Transport Engineering Report

54 George Alexander Way, Coomera

Proposed ROL and Multiple Dwelling
Development

Table 1.1: RFI Response

Figure 7.1: Motorcycle relocation recommendation on basement level 1

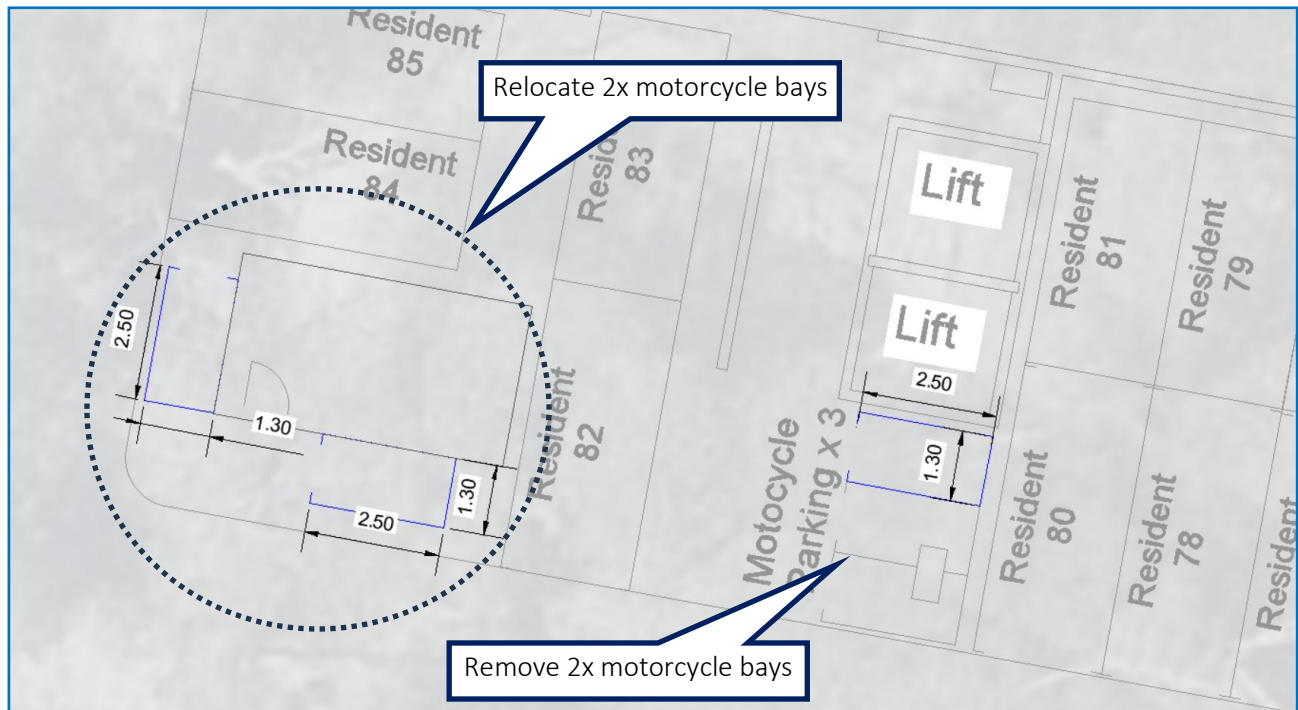
12.	Based on review of the submitted drawings against the requirements of AS2890.1:2004, Officers have identified several matters of non-compliance requiring submission of amended drawing as follows: <i>Buildings 1-3</i> a. A designated turnaround area has not been provided at the far end of the visitor car parking area prior to the security gate. The applicant is therefore requested to submit amended drawings and provide associated swept paths on a separate drawings showing the turn around area and the capability of a B99 to turn around in this area and exit the basement in a forward gear. <i>Townhouses</i> b. Based on review of the vehicle crossing alignment and positioning of car parking on each townhouse lot, Officers are concerned that it will be difficult for vehicles to access the parking spaces on the outside, particularly when a car is parked on the inside space of each unit. The applicant is therefore requested to either: i. Submit amended drawings showing a tandem car parking arrangement for each dwelling; or ii. Submit swept paths prepared by the project Traffic Engineer showing a B85 vehicle accessing townhouse carport and garages when a car is parked in the inside space of each unit.	B99 vehicle turn around swept paths at the end of each visitor parking area are provided in Appendix B. B85 vehicle swept have been completed for vehicles accessing a the carport/garage while another car is parked in the space. Refer to Appendix B.

The proposed car park will be provided across two to three levels at-grade and within the basement. Visitor parking will be located in front of the security line at-grade with all residential car parking spaces located behind security line. A minor adjustment to motorcycle parking bays in the level 1 car park is recommended to avoid conflict with the basement columns. The recommended bay locations are provided in Figure 7.1.

MCU DEVELOPMENT - SITE ACCESS (INTERIM SCENARIO)
DRIVEWAY & MEDIAN DETAILS - CONCEPT

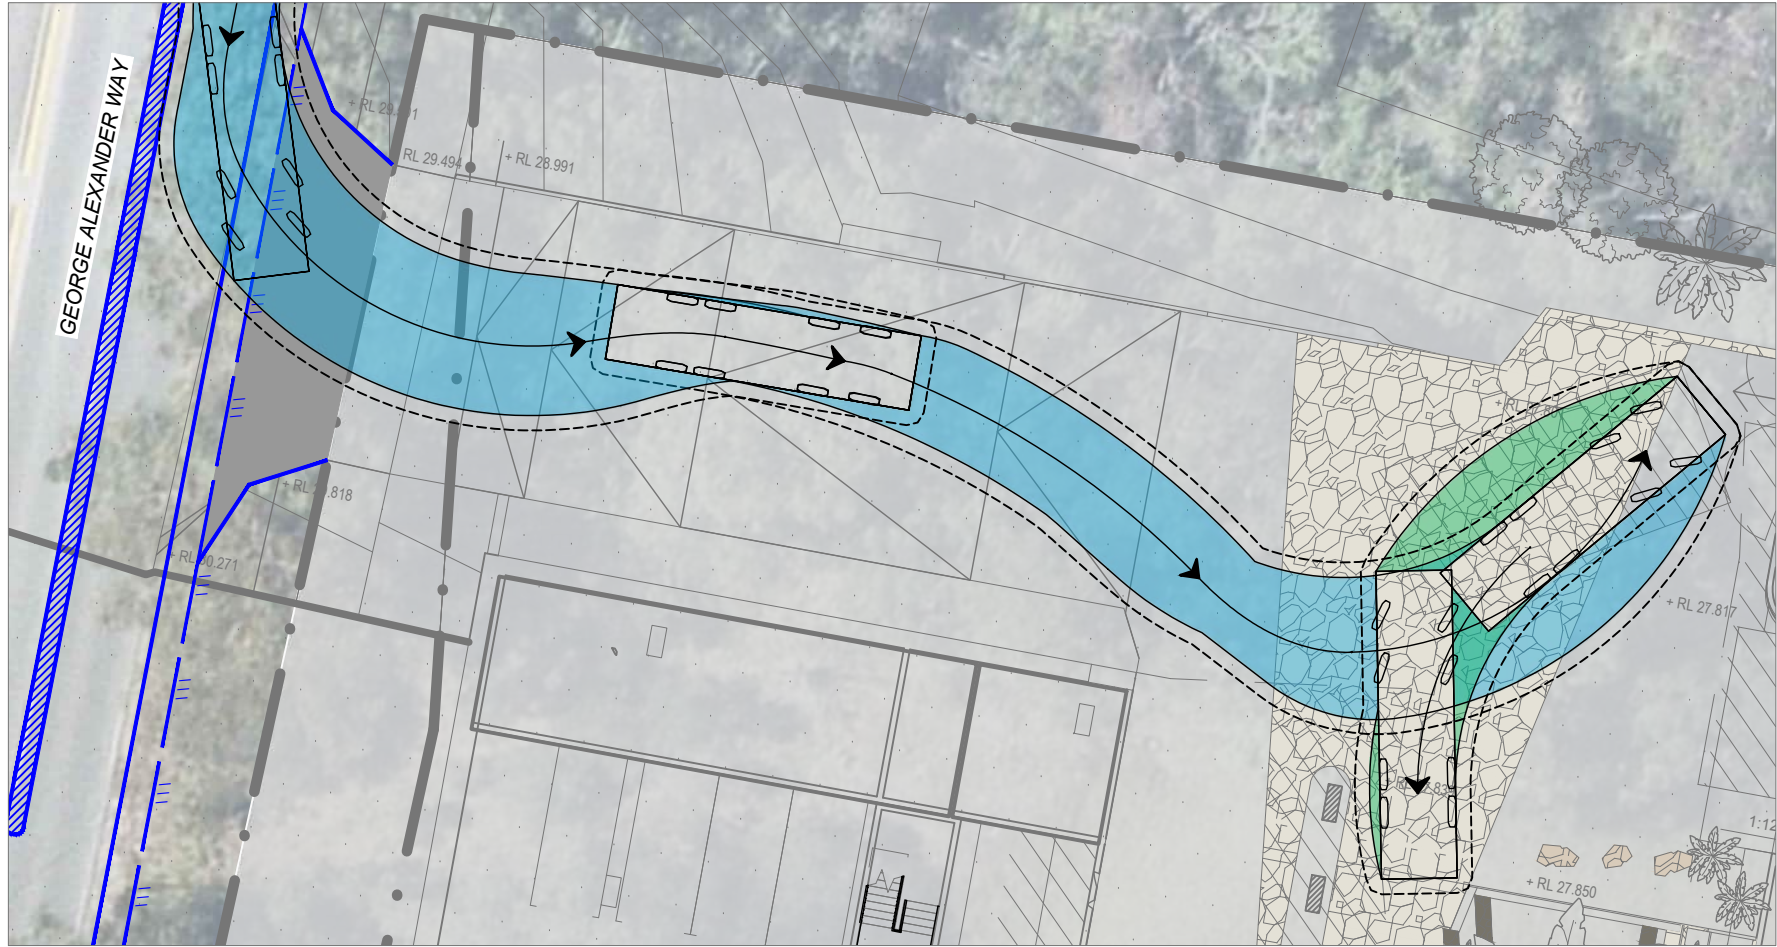
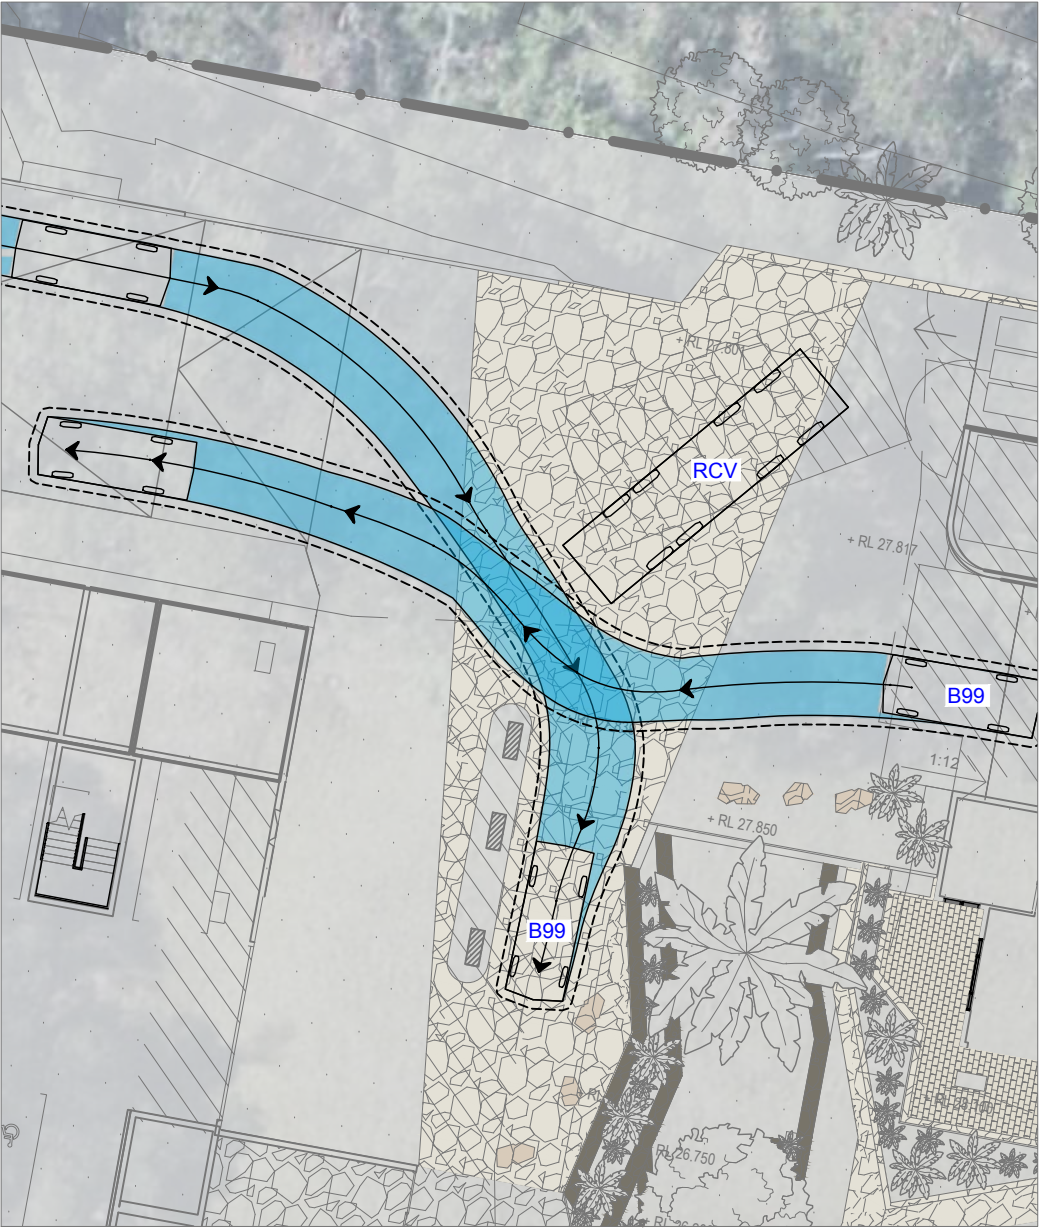
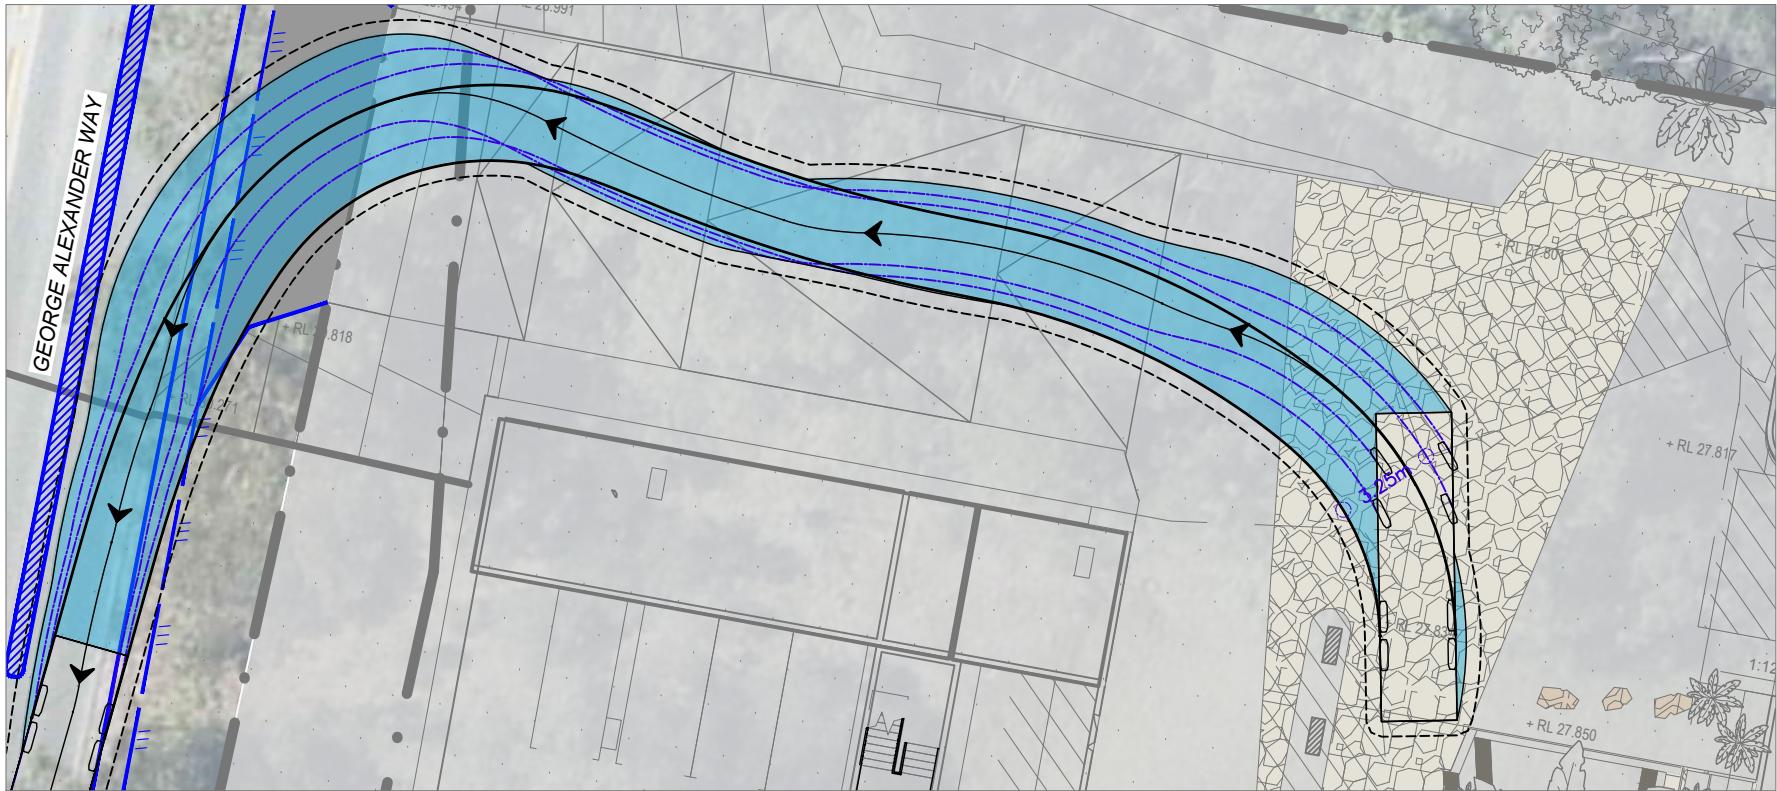
RCV Swept Path		
22	Council acknowledges the RCV swept path diagrams provided by the applicant, however, to confirm overall feasibility of waste servicing, the applicant is requested to provide amended Swept Paths for the design Waste Collection Vehicle complying with AS2890.2 and certified by an appropriately qualified RPEQ that a Waste Collection Vehicle (WCV) can adequately manoeuvre unimpeded through the development to the bin storage/servicing point as outlined below: i. Swept path analysis is to be generated by AutoTurn, AutoTrack or similar. ii. Plans must demonstrate vehicle specifications in accordance with the 'City Plan Policy – Solid Waste Management' including the wall-to-wall turning radius as nominated in Appendix C of SC6.15 City plan policy – solid waste management code. iii. Manoeuvring clearances in accordance with AS2890.2 must be clearly depicted on drawings and demonstrate no obstructions exist for all waste servicing manoeuvres. iv. Reversing movements on-site are to be kept to a minimum and access to the development from the road is to comply with AS2890.2.	The Front-lift RCV swept paths are signed by RPEQ Engineer and shown in Appendix B.
